# Access Compliance Report

## Public Rights-of-Way

### (Curb Ramps)

Intersection ID: N/A	Main Street: WALNUT_LOOP_RD	Cross Street: WOODBINE_WALK_RD	Location: NW
ADA ID: 2DDCB332A1D4	Ramp Type: Perp	Initial Pass/Fail: Fail	Overall Compliance: No
Severity Score: 13.75			
Codes/Mitigation Info/Possible Solution		Field Measurements/Component Compliance

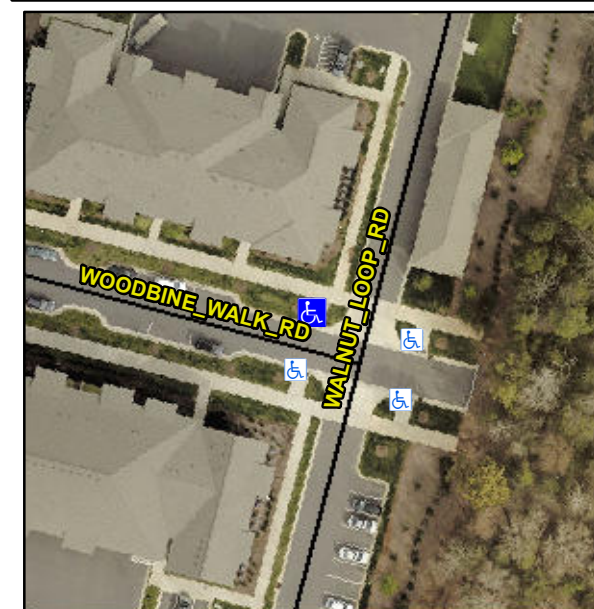
**R304.2.2, R304.5.3**

Compliance	Description	Data	Compliance	Description	Data
N/A	Ramp Length (in)	82.0	No	Ramp Slope (%)	8.6
Yes	Ramp Width (in)	94.0	No	Ramp XSlope (%)	2.9
N/A	Flare Type LT	N/A	N/A	Flare Type RT	N/A
N/A	Flare Slope LT (%)	N/A	N/A	Flare Slope RT (%)	N/A
N/A	Flare Traversable LT?	N/A	N/A	Flare Traversable RT?	N/A
N/A	Landing Length (in)	N/A	N/A	DWS Provided?	N/A
N/A	Landing Width (in)	N/A	N/A	DWS Contrast?	N/A
N/A	Landing Slope (%)	N/A	N/A	DWS Length (in)	N/A
N/A	Landing X Slope (%)	N/A	N/A	DWS Full Width?	N/A
N/A	Landing Curb? (Y/N)	N/A	N/A	DWS Offset (in)	N/A
N/A	Shared Landing?	N/A			
N/A	Gutter Ponding?	N/A	N/A	Gutter Slope (%)	N/A
N/A	Gutter Lip Ht (in)	N/A	N/A	Gutter X Slope (%)	N/A
N/A	Painted X Walk1?	No	N/A	Painted X Walk2?	N/A
	X Walk 1 Direction	To SW		X Walk 2 Direction	N/A
N/A	X Walk 1 Width (in)	N/A	N/A	X Walk 2 Width (in)	N/A
	X Walk 1 Slope (%)	0.8		X Walk 2 Slope (%)	N/A
	X Walk 1 X Slope (%)	1.9		X Walk 2 X Slope (%)	N/A

**Remove & Replace Entire Ramp.**
